5. PRELIMINARY SITE PLAN REVIEW (File Number JPLN2022-0017) – Proposed Abbey Estates Site Condominium, 4 units/lots, North side of Wattles, West of Rochester, Section 15, Currently Zoned R-1C (One Family Residential) District

**Preliminary Site Plan Approval for a
Site Condominium Plan
For
City of Troy, Michigan**

Applicant:	Steve Muci
Project Name:	Abbey Estates
Plan Date:	May 10, 2022
Location:	571 and 589 Wattles
Zoning:	R-1C, one-family attached residential
Action Requested:	Preliminary Site Condominium Approval

FRONT ELEVATION

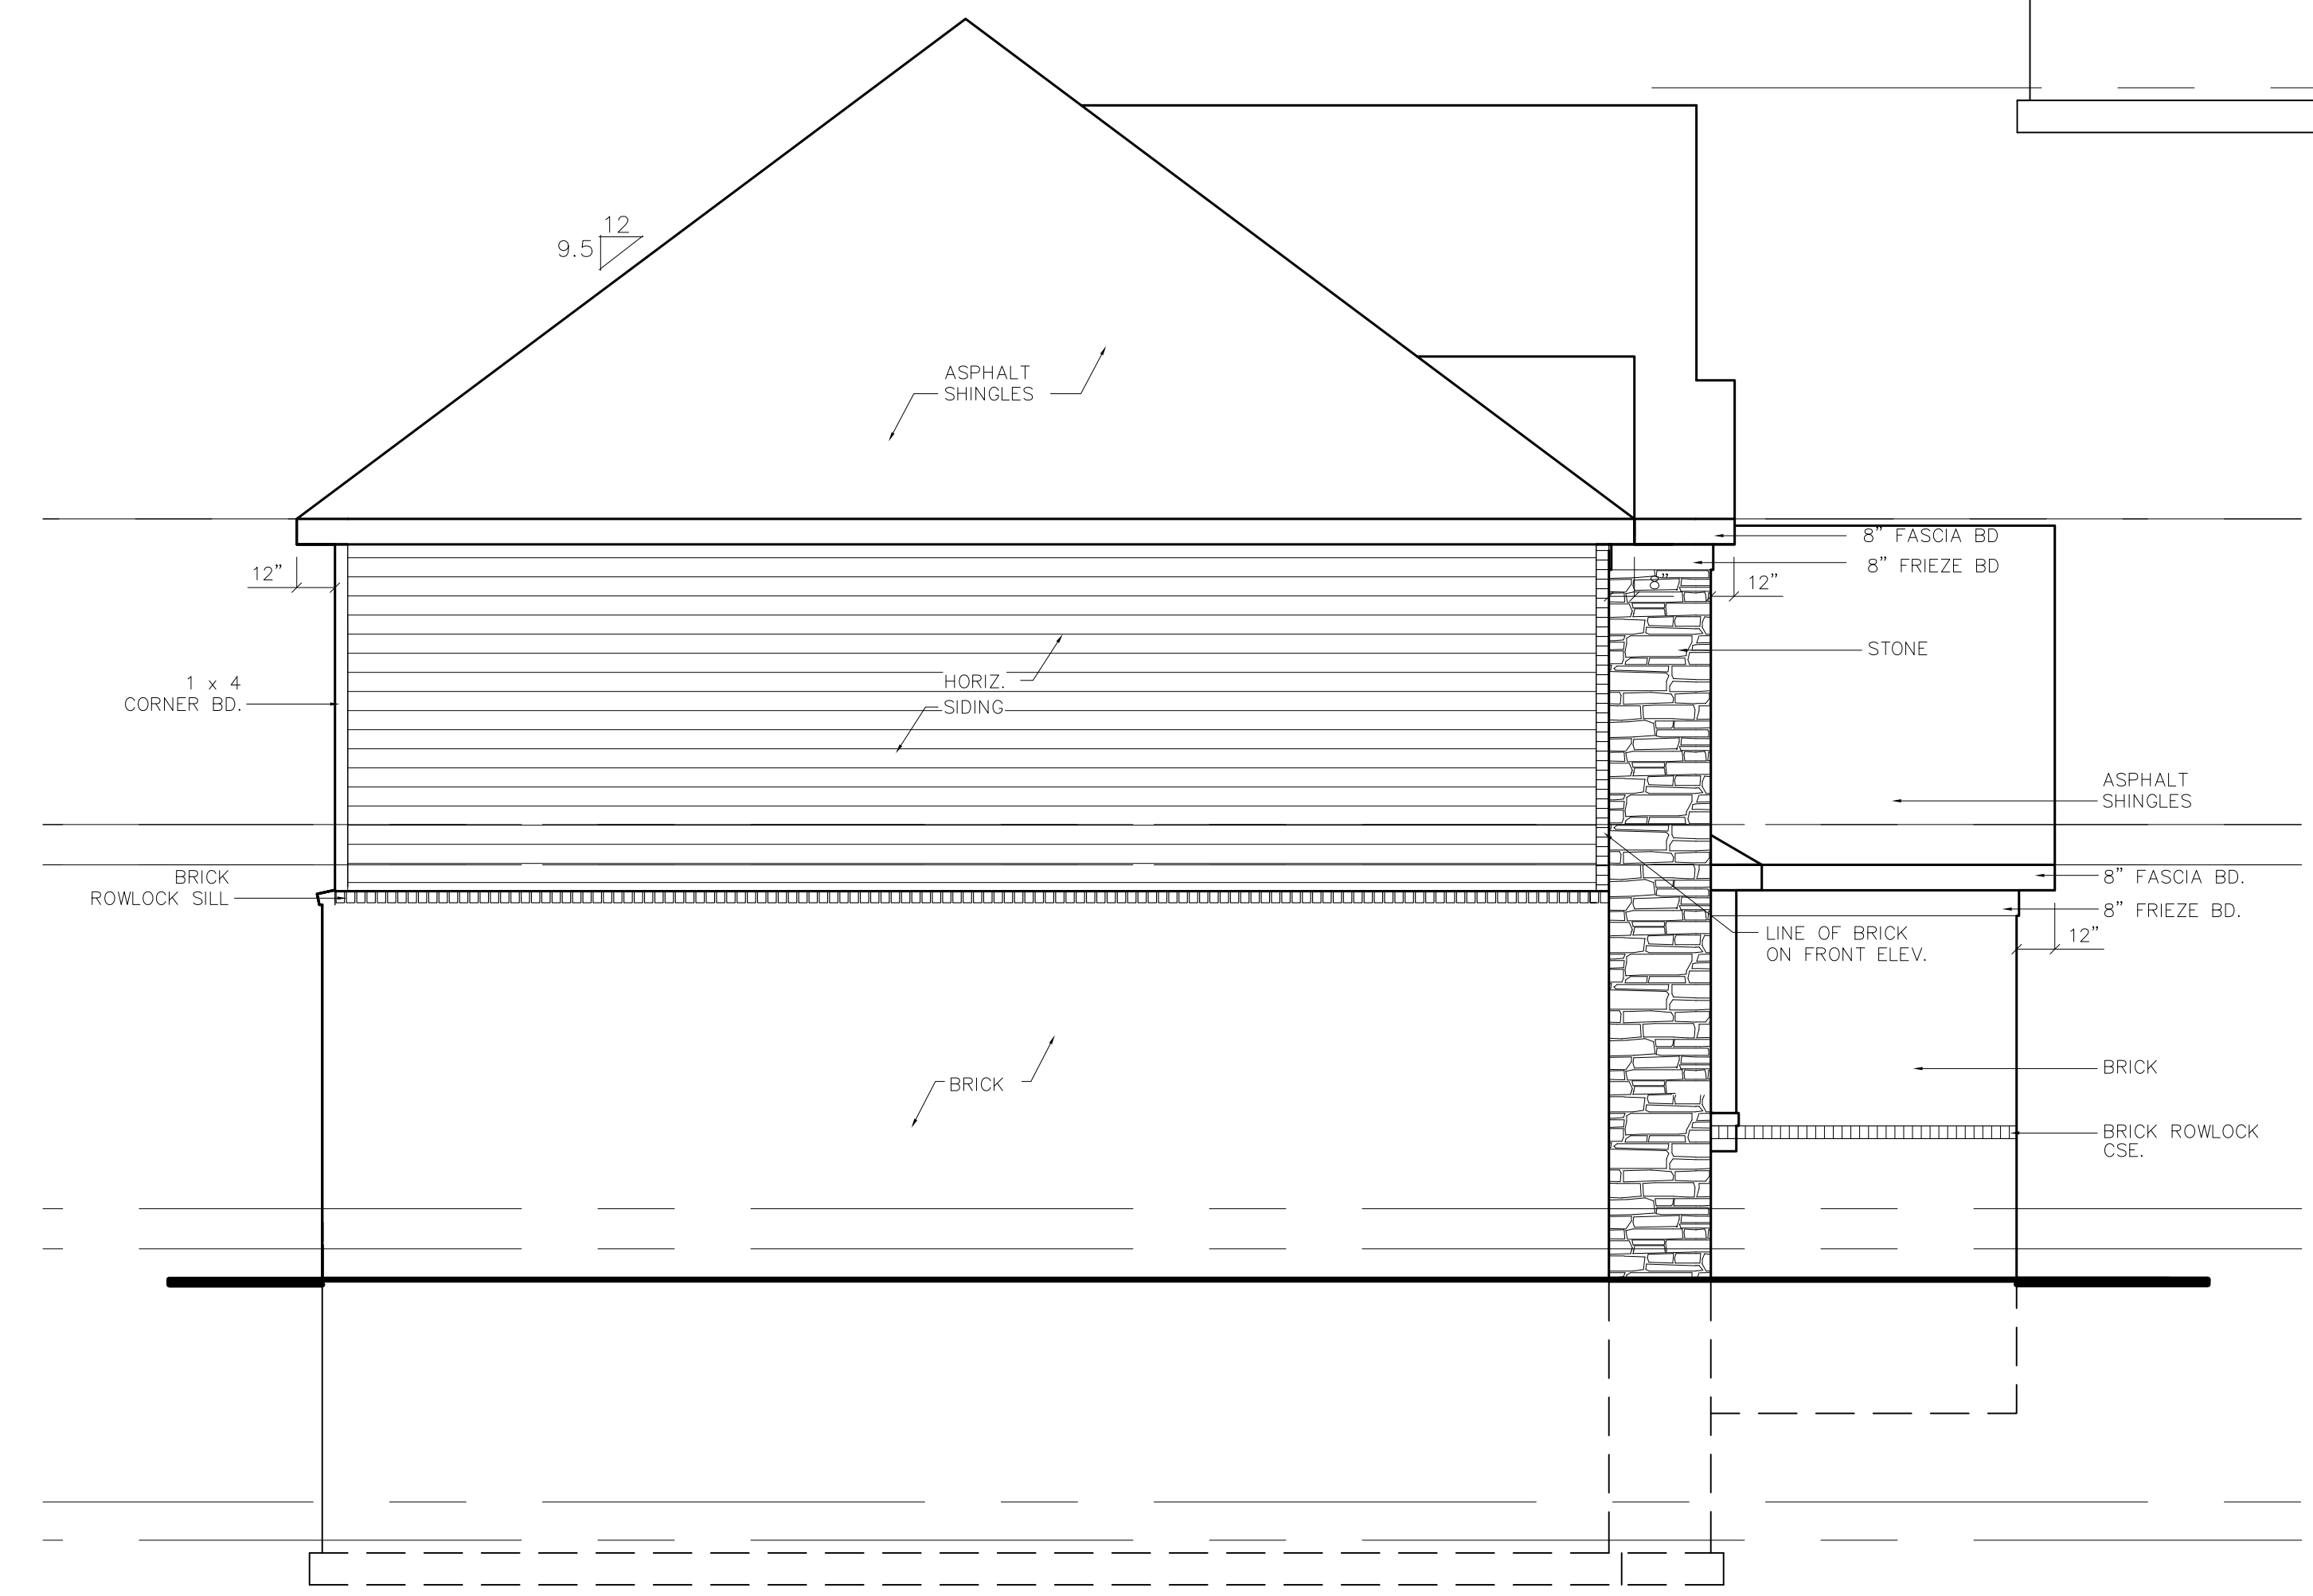
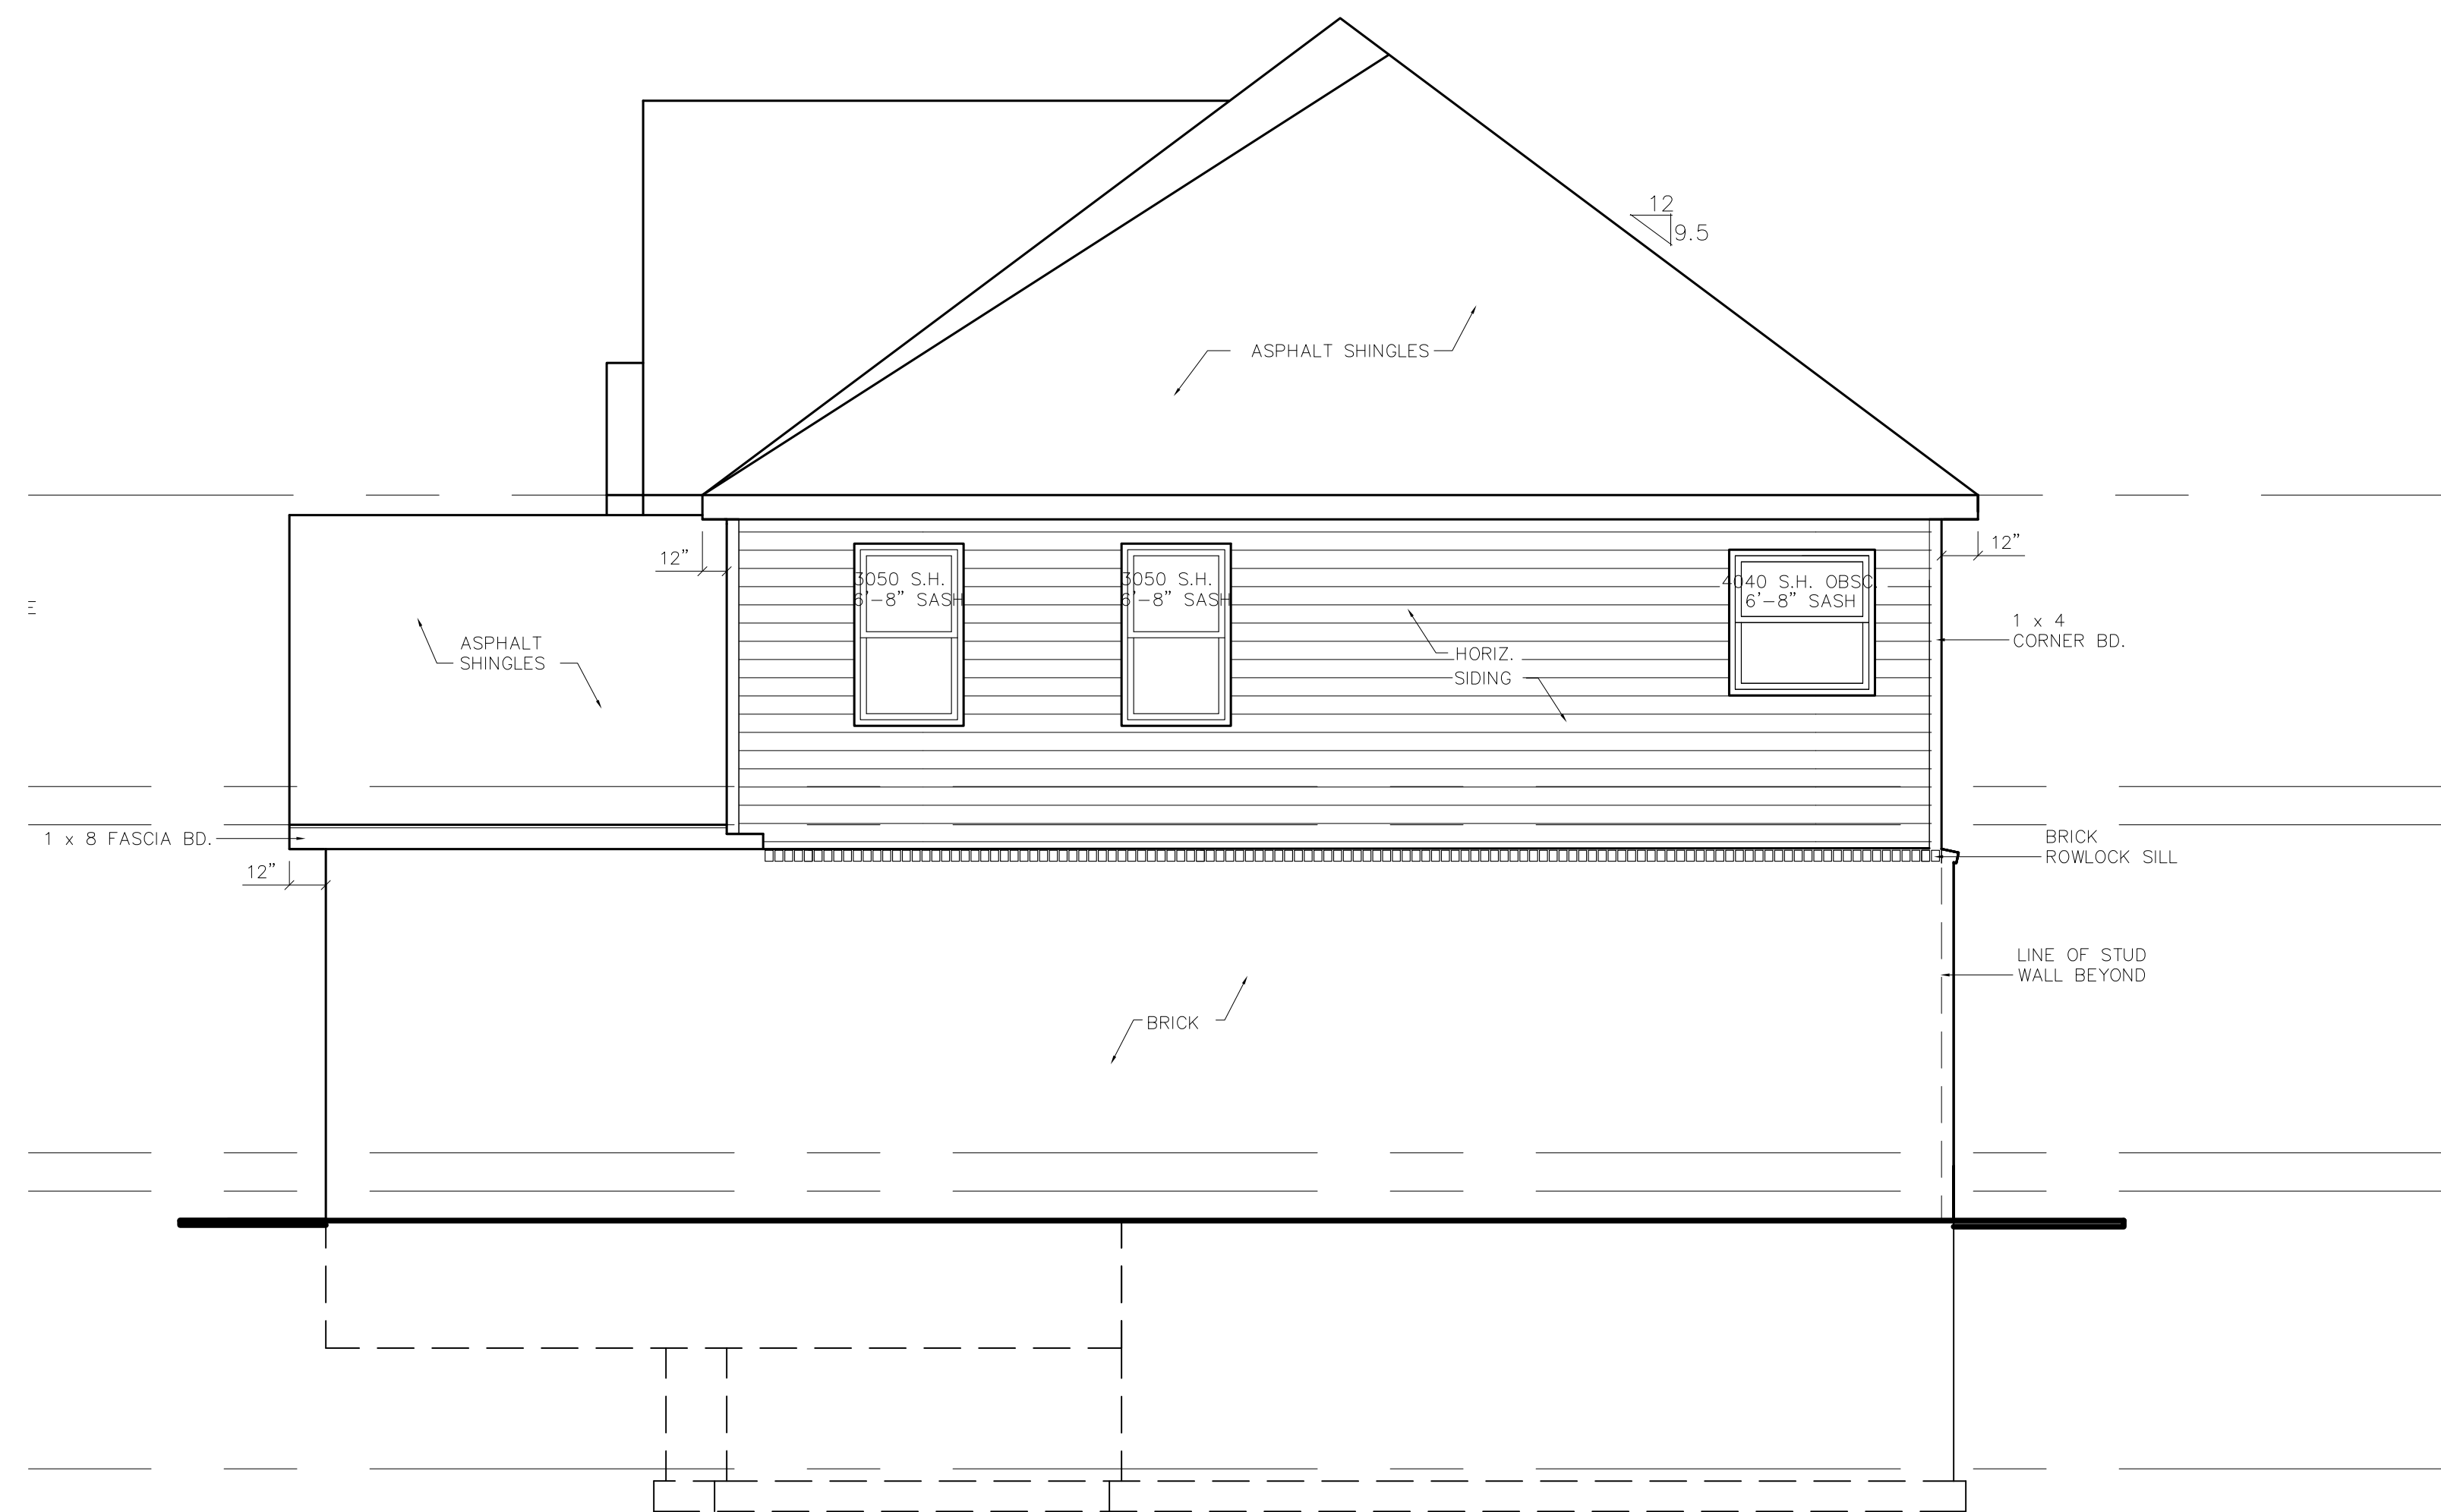
The applicant shows a height of 33-feet to the peak. 30-feet is the maximum and measured to midpoint of roof. Applicant should confirm roof height.

Items to be Addressed: Confirm height.

The applicant submitted five proposed elevations, with all based on the same floor plan. Materials are not indicated.

Items to be Addressed: Provide materials.

1. Confirm roof height.
2. Provide materials.
3. Resubmit landscape plan stamped by Landscape Architect.
4. If trees two (2) landmark trees in ROW die during the construction phase of the development, applicant is required to replace street trees as required in the Zoning Ordinance.
